INTEGRATED LEAK RATE TEST
FOR ST. LUCIE NUCLEAR
POWER PLANT (UNIT #2)

TECHNICAL EVALUATION REPORT
April 1987 - June 1987

VIKING SYSTEMS INTERNATIONAL

Prepared for
U.S. Nuclear Regulatory
Commission

Figure 1: Relative Humidity in Containment versus time elapsed since start of leak rate test

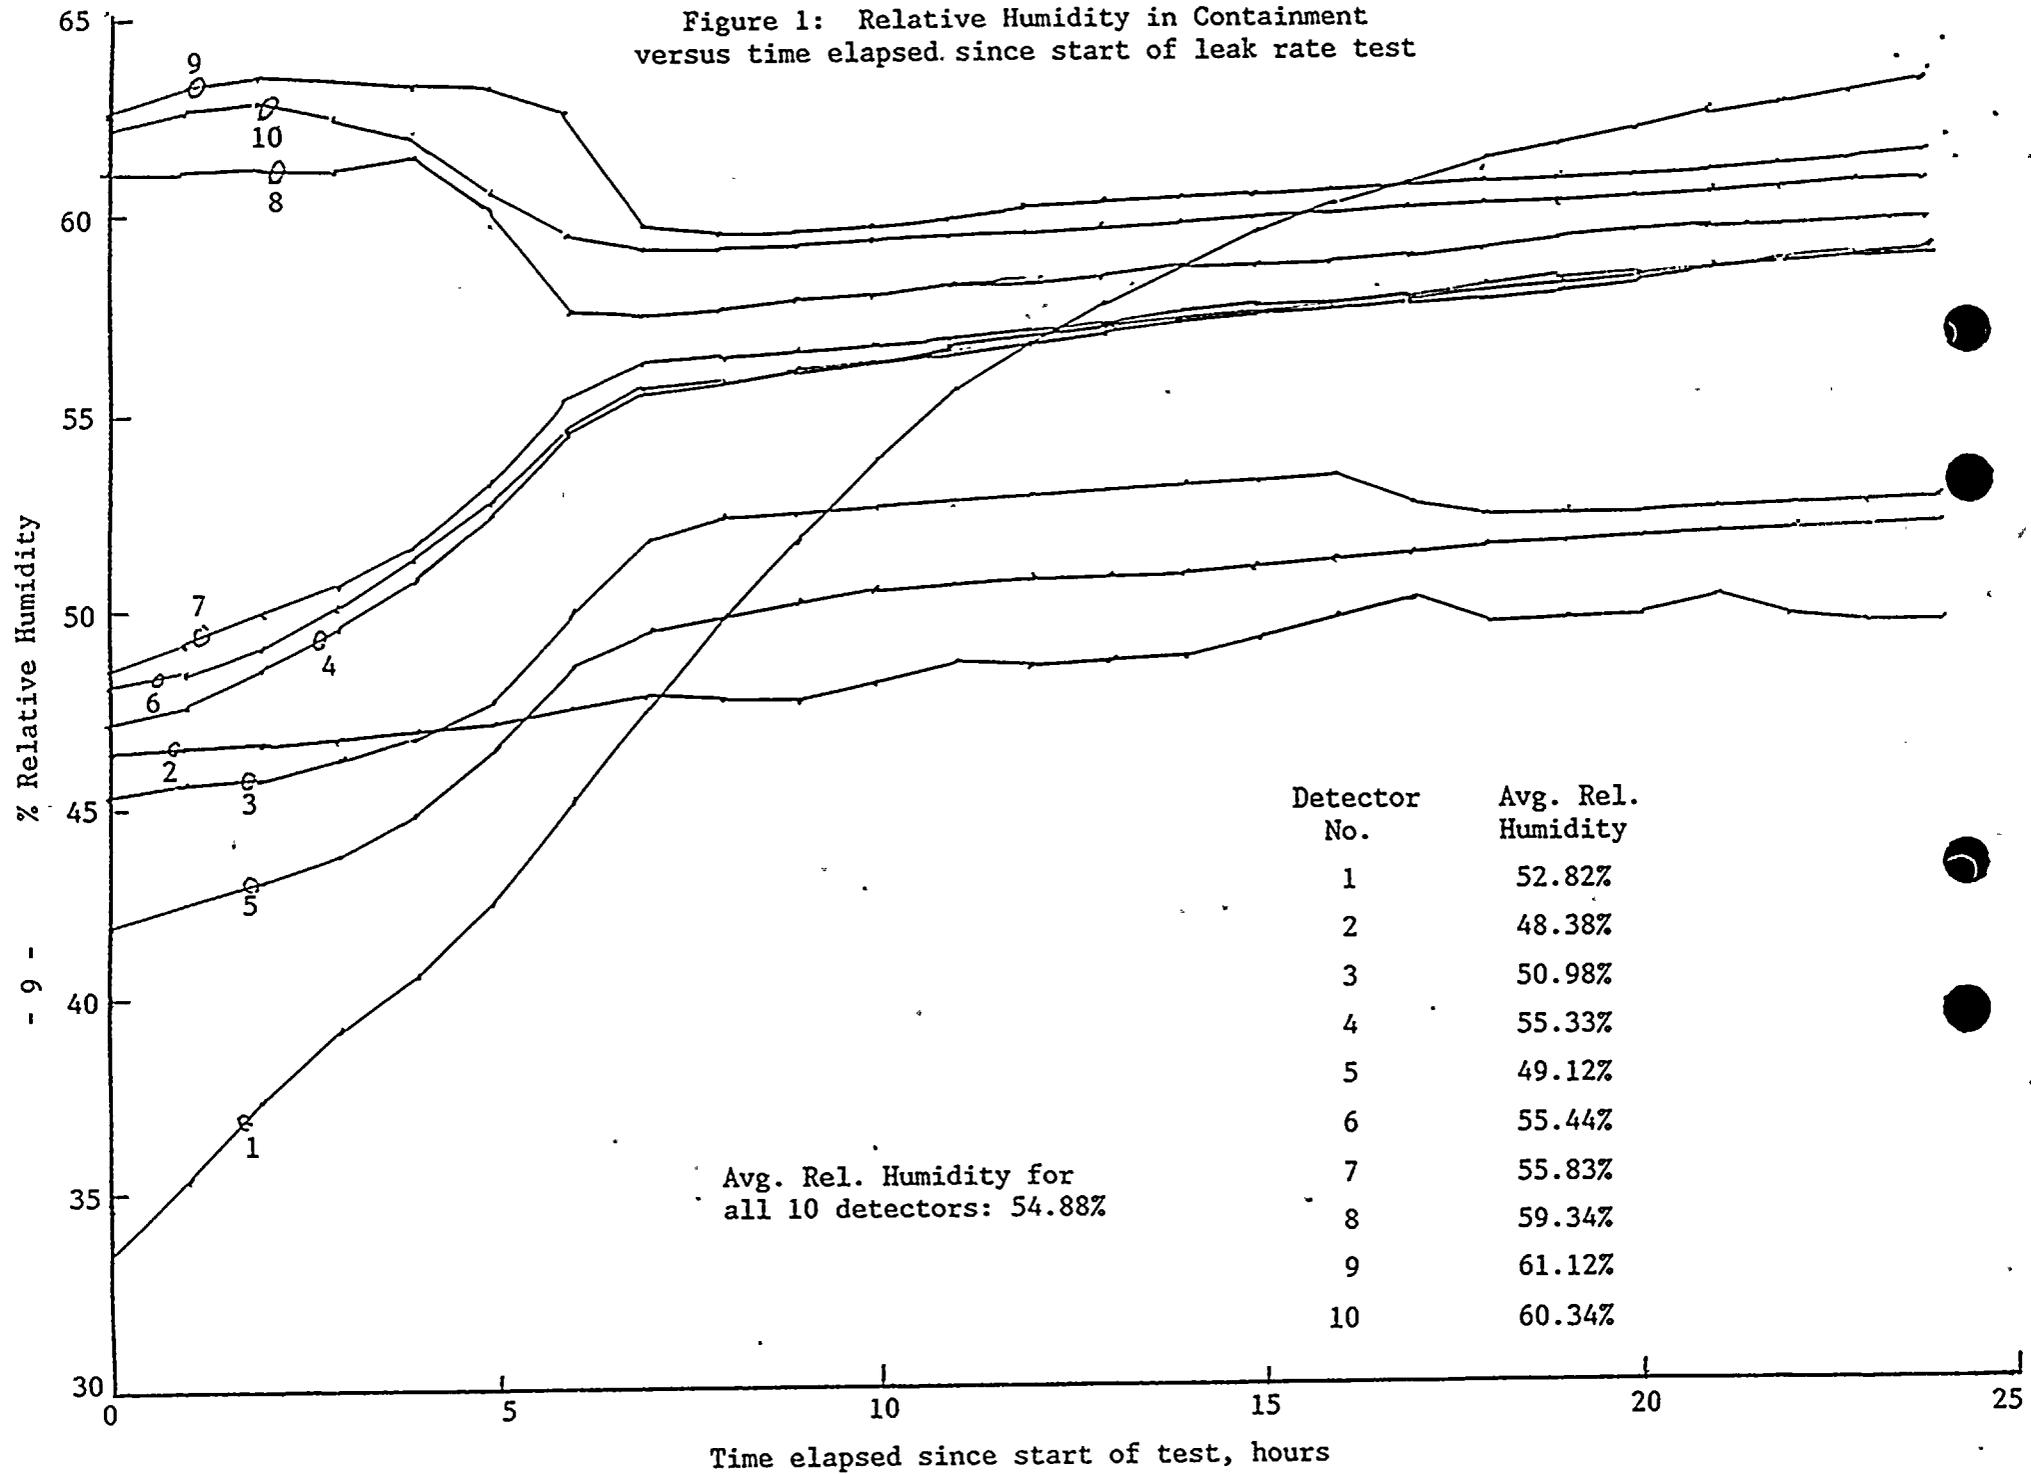
The values for humidity obtained from the relative humidity detector RHD #1 indicated a wide variation during the course of the ILRT. The values increased from 33.62% RH at ILRT test initiation to 63.9% near the end of the ILRT test. The relative humidity, according to this detector was apparently still rising.

Such extreme variation in relative humidity is not in accord with relative humidities obtained from the other relative humidity detectors and therefore appears anomalous. This individual anomaly does not appreciably affect the overall test results, as may be seen in figure 1 where the average relative humidity is 54.88%.
